CHANGE ORDER

CHANGE ORDER NO.: 8

PROJECT: PB 05-6 PBA Concourse C Gate Expansion

Applicable Drawing(s): SK-A36 & SK-A37

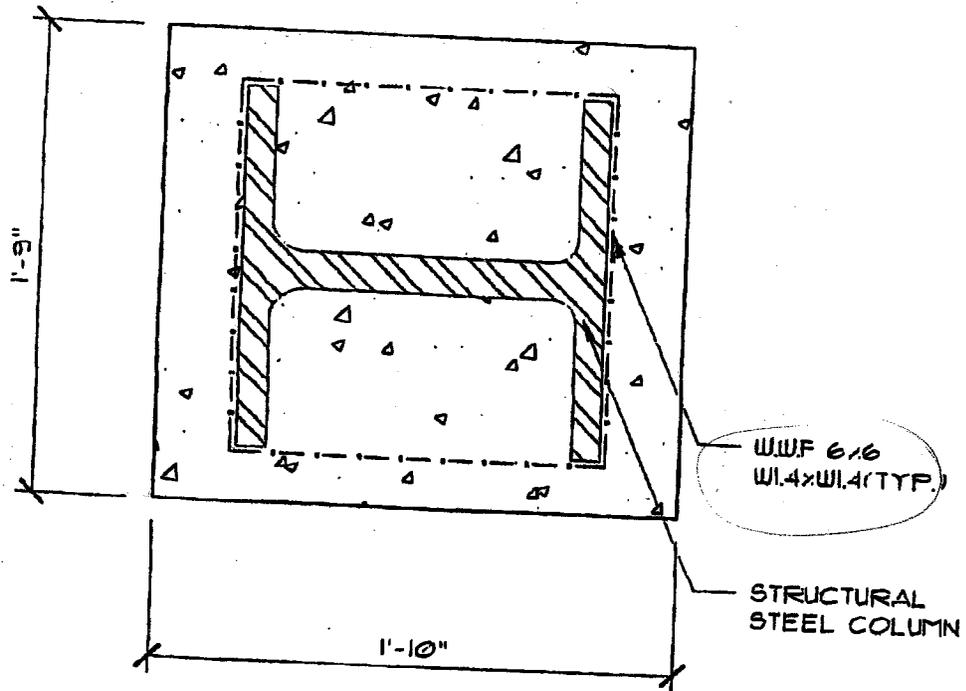
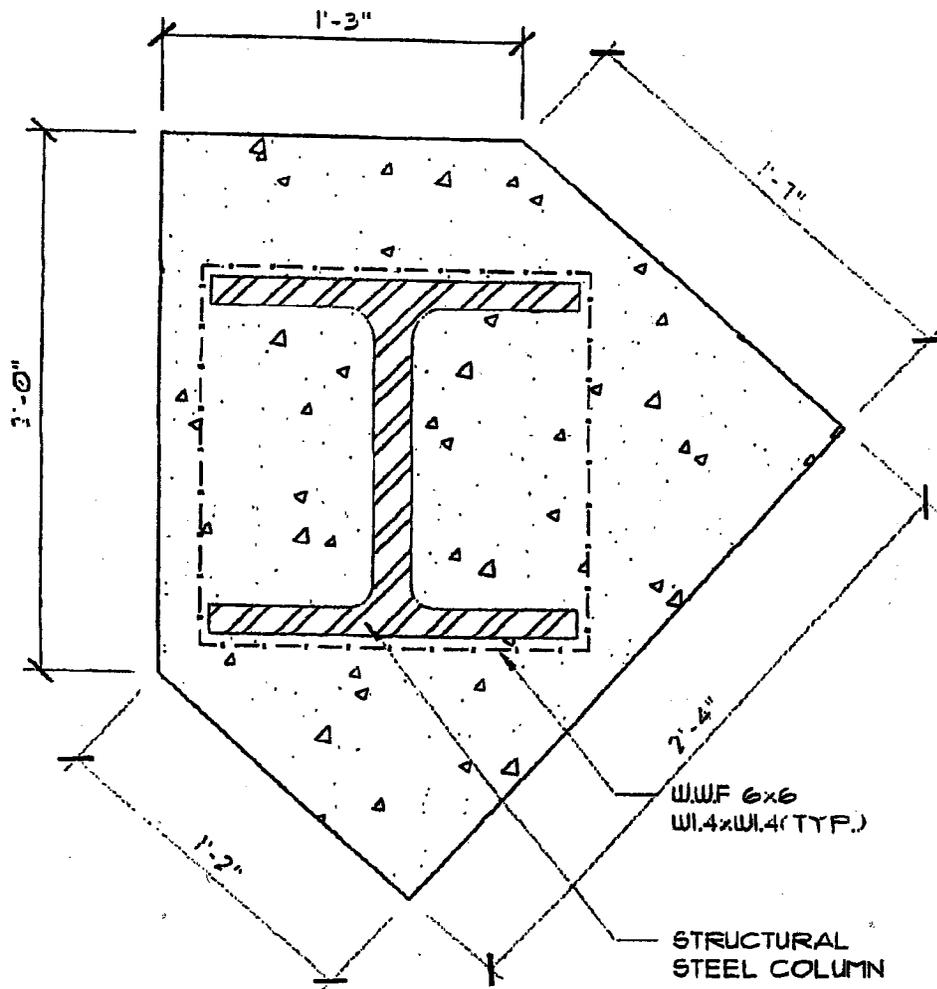
FB#28 was issued to add wire mesh around these 4 non-load bearing exterior steel columns per sketch SK-A37 due to not being shown in bid set detail detail 6/A-5.01.

Addition detail was required for the reinforcing at the non round concrete encased columns
